Sumter City-County Planning Commission

Staff Report

SV-13-10, Horatio-Hagood Rd. (County)

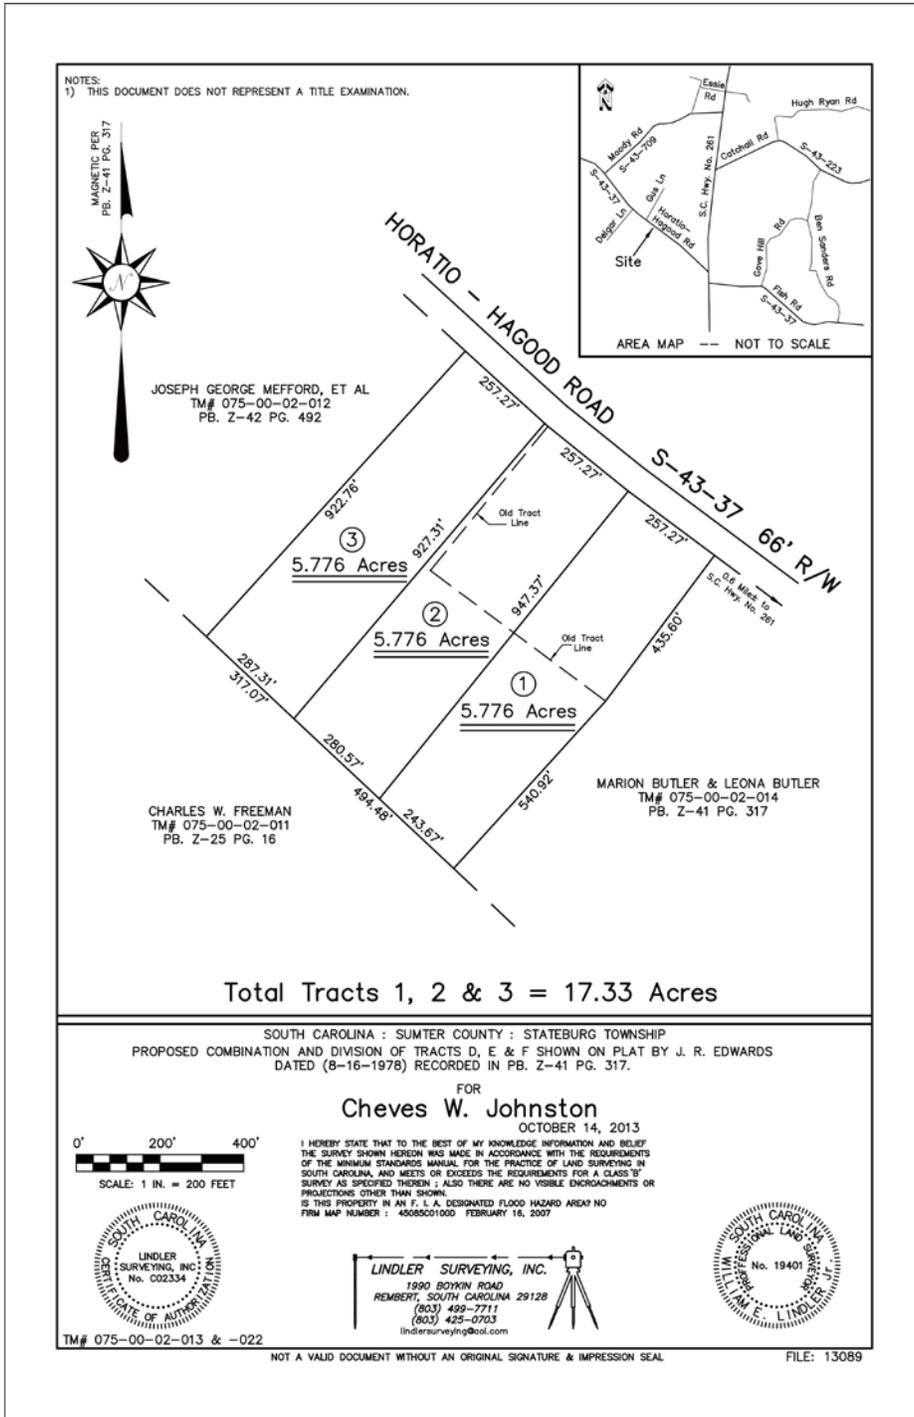
The applicant wishes to combine the two parcels and then subdivide the property as shown in the diagram below to create three new parcels, each +/- 5.776 acres in size. The width of each proposed lot is 257.27', and 2.5 times this measurement is 643.175'. The actual depth of the lots is +/- 927'. Therefore, these proposed parcels will require a variance from the residential lot width to depth ratio requirements found in section 8.e.13.f of the Sumter County Zoning & Development Standards Ordinance. The proposed layout was necessary in order to grant equal acreage to the three parcels. The applicant intends to sell the lots once division takes place.

Staff recommends approval of this request. The proposed layout gives each parcel more than the required minimum lot frontage and plenty of road access. This layout in fact is more in keeping with the lot dimensions of the existing lots on both sides of these proposed lots.

The Sumter City-County Planning Commission at its meeting on Wednesday, October 23, 2013, approved this request as presented.
